Cairns Shipping Development Project EIS - Flood and Dredge Materials Mobilisation Technical Studies - Investigation for the Northern Sands Placement Site Alternative Option

Reference: R.B22074.014.00.Further Response to IR Final
Date: December 2017
Confidential

Prepared for: Flanagan Consulting Group

Prepared by: BMT WBM Pty Ltd (Member of the BMT group of companies)

Figure:
4-1

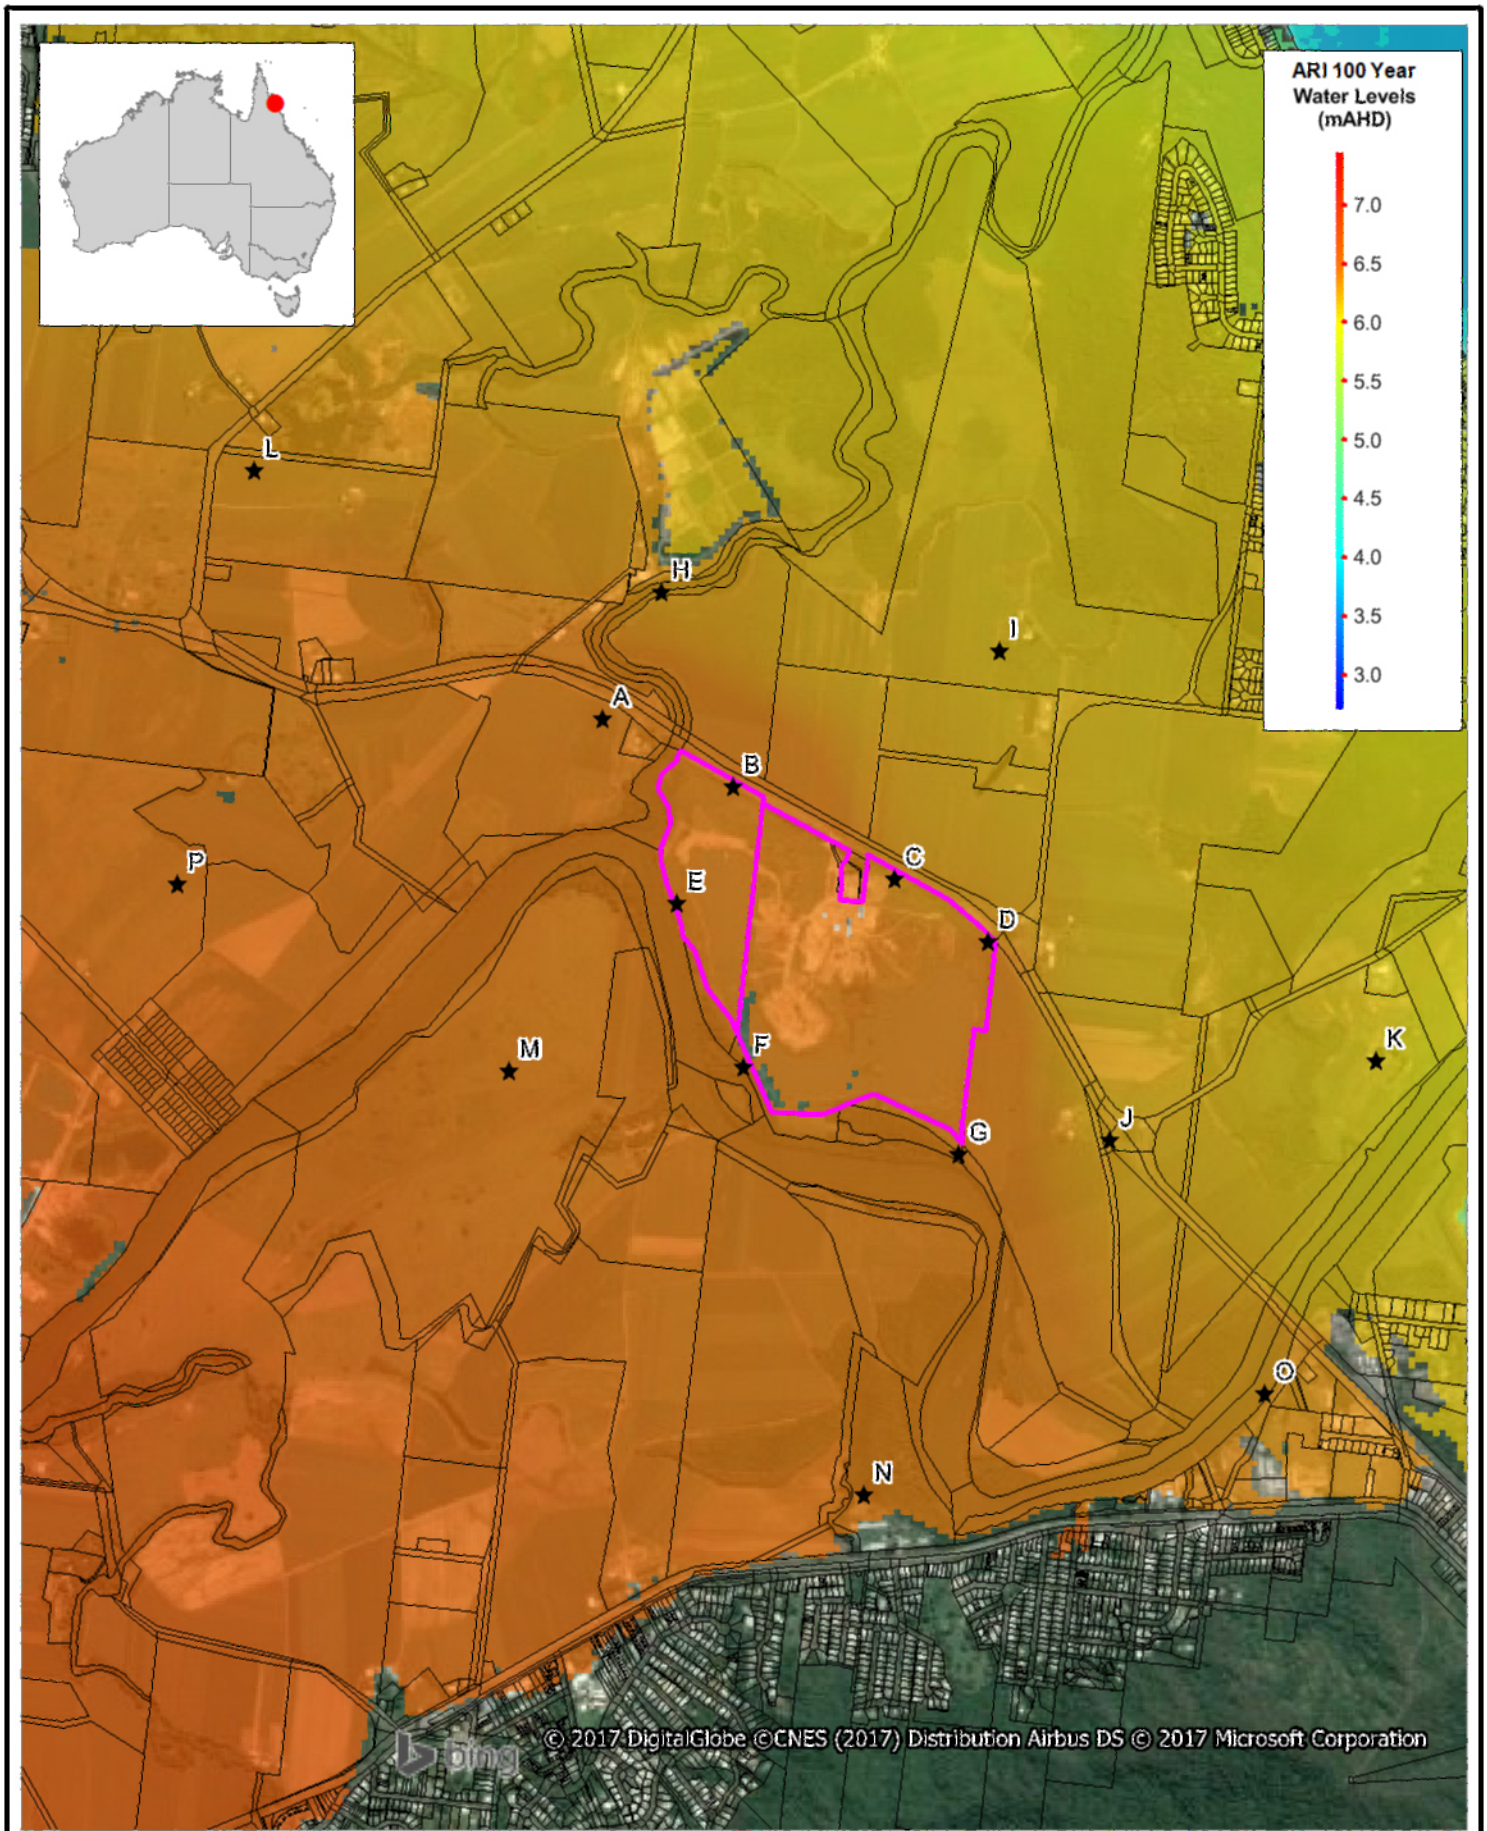
CRC require full calibration and validation details for the TUFLOW flood model used. The TUFLOW model used was created for the development of the AQUIS project, and was calibrated against the 2007 MIKE 21 Council approved flood model previously developed by Connell Wagner (now Aurecon). It was developed quickly to allow more rapid development option testing over the Council model.

Figure 4-1 shows the locations of the comparison points and Table 4-1 provides results of comparisons.

The comparison of results demonstrates that the TUFLOW model adequately matches the MIKE 21 flood model across a range of flow events. Comparisons across the entire delta can be provided if required. There is close agreement between the two models in the area of the delta that included the Aquis site as that was the purpose of its original development however there is close agreement generally across the delta. It is noted that Council accepted the outcomes of the Aquis assessment using the TUFLOW model.

It is noted that, prior to finalisation of the detailed design and prior to downstream operational works applications, the final adopted containment arrangement will be checked for hydraulic impacts in Council's MIKE 21 flood model.

Figure:
5-1

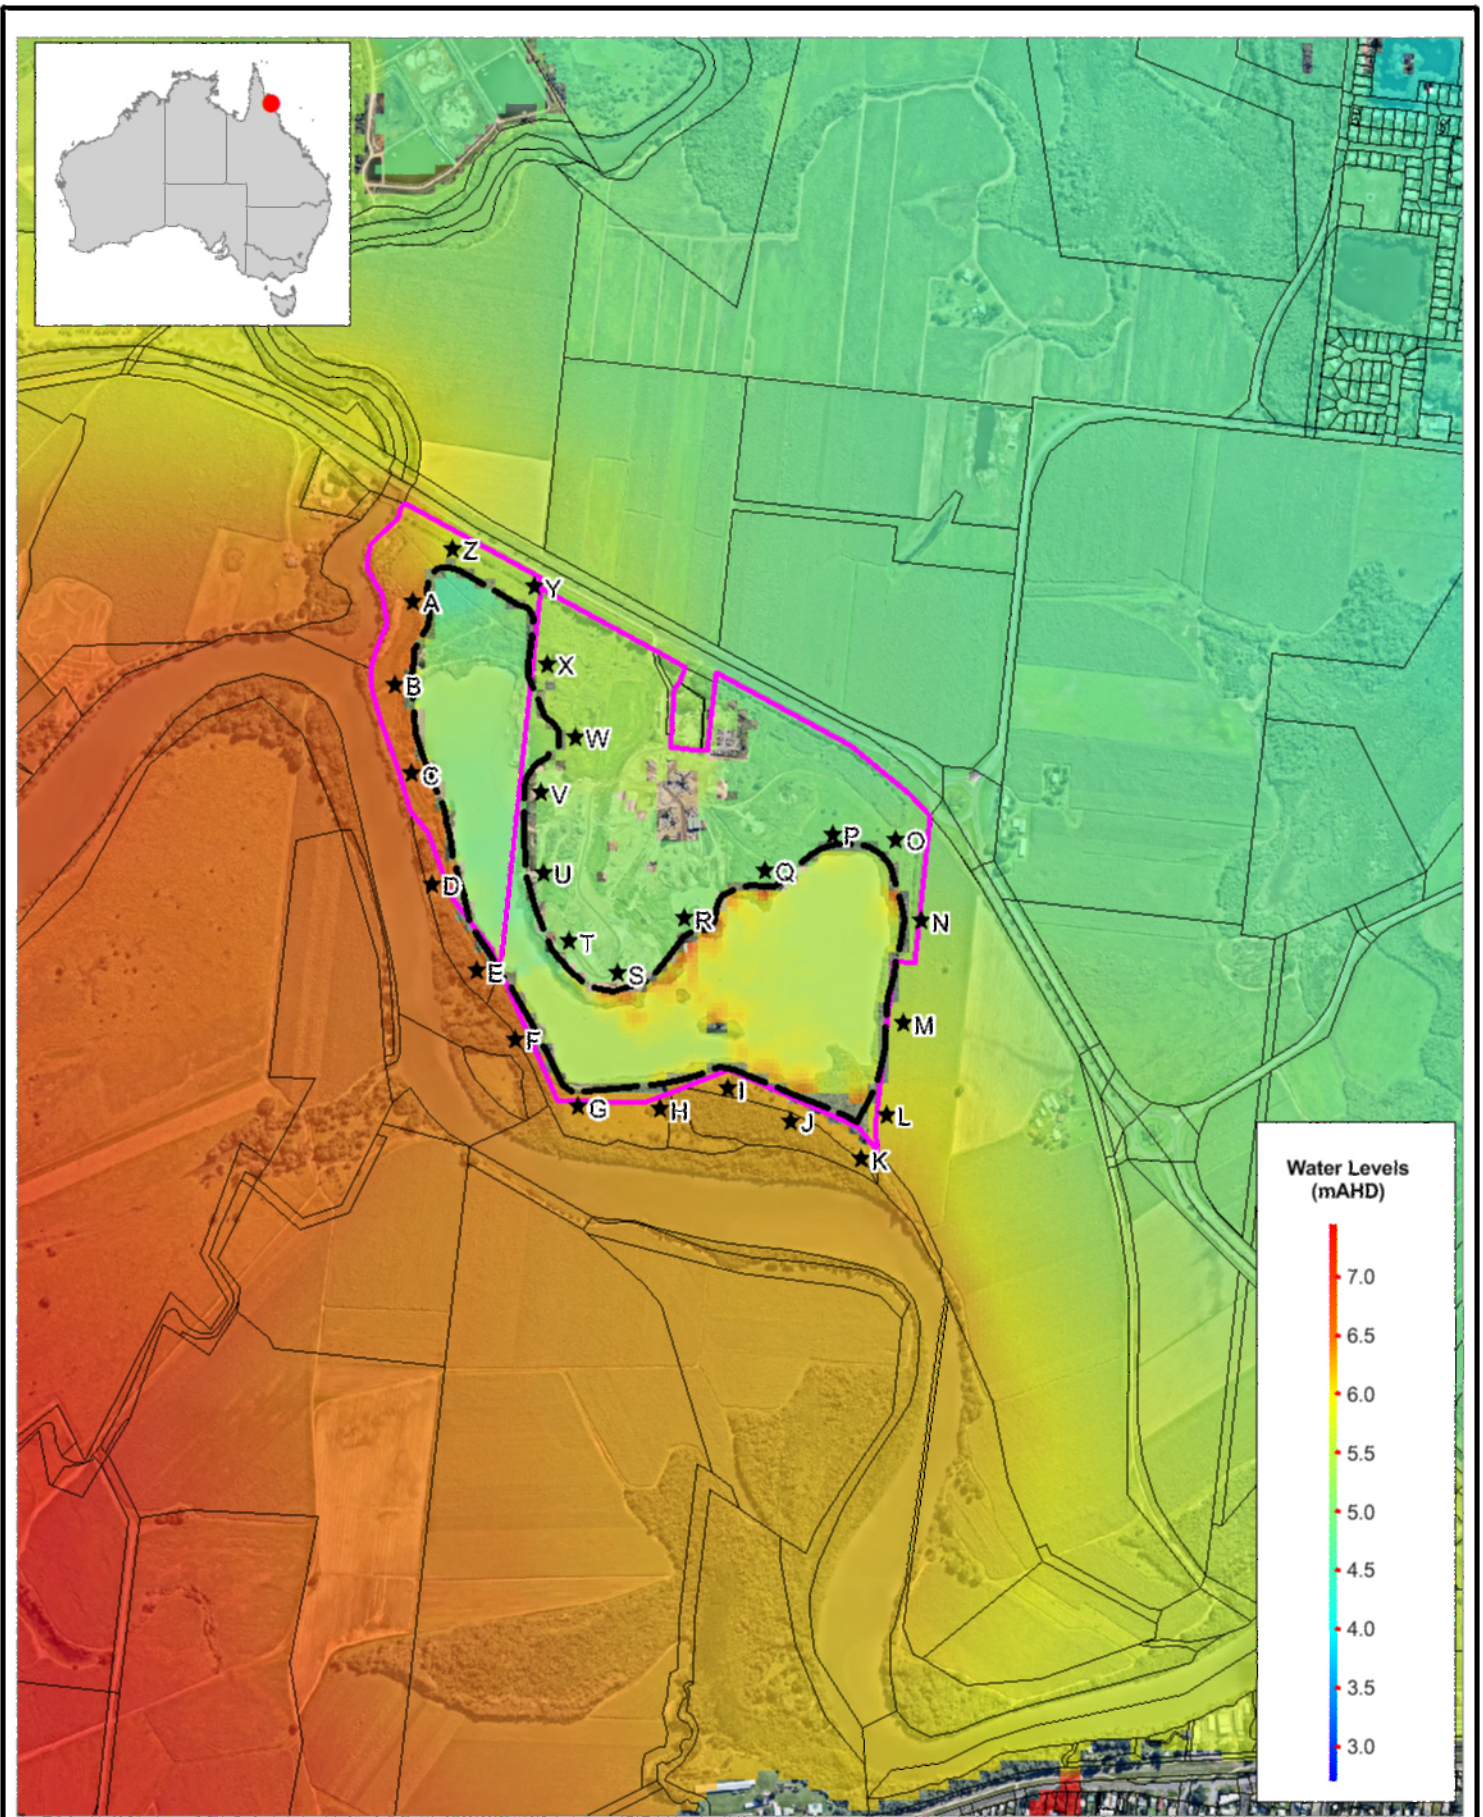
- (a) Flood model documentation.
- (b) Flood impact assessment scenarios and flood cases to be assessed.
- (c) Port-dredge material placement and final landform conditions.
- (d) Sensitivity to high direct rainfall and contingency measures.
- (e) Severe storm / loss of life consideration.
- (f) Embankment failure and consequences.
- (g) Proposed bund levels and freeboard details.
- (h) Erosion / scour in overtopping events and management.
- (i) Flood hazard assessment.
- (j) Addition water level and velocity information.
- (k) Risk of remobilisation.

Figure 5-1 shows the location of additional reporting points around the containment area. Table 5-1 below shows corresponding peak water levels across a range of ARI events.

Top of bund levels will be set to provide immunity to the ARI 100 year(1% AEP) river flood event.

Figure 7-1 Highway Levels Adjacent to the Site

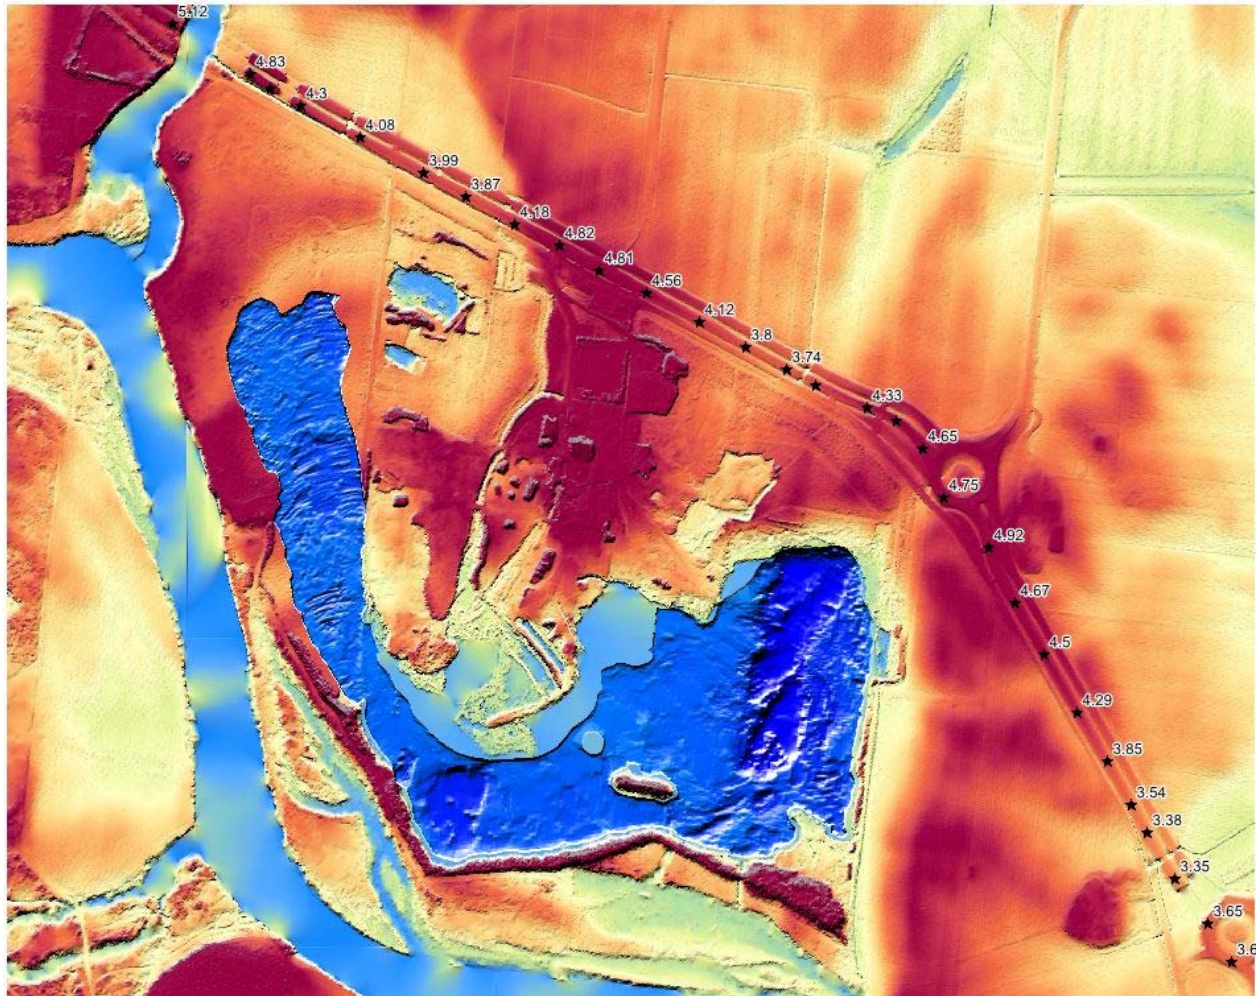
- (a) Bund wall Consequence Category Assessment and impact of embankment collapse.
- (b) Bund wall design and hydraulic performance of structure.
- (c) River flooding and embankment protection measures, including spillways and erosion protection.

Assuming an entire 200m length of the bund were to collapse in the north-west corner, the 1m depth of water will form a dam break wave, that will travel to the north-east. By the time this reaches the road, the wave will have spread to frontal width of approximately 400m with a depth of 0.5m.

The highway is 0.5m to 1m higher than the adjacent site topographic levels. The water that has flowed through the embankment breach will pond behind the road embankment until the available storage is filled, then sheet flow overtopping of the highway will occur, at depths no greater than 300mm (based on my empirical calculations).

Hence, even under this worst-case scenario, there is no significant risk of loss of life to people driving on the highway. A possible additional mitigation strategy would be to construct a 1m high earth mound along the highway frontage to fully contain any water and spoil discharged under such an unlikely dam break situation.

Figure 7-1 shows the levels along the highway adjacent to the site.
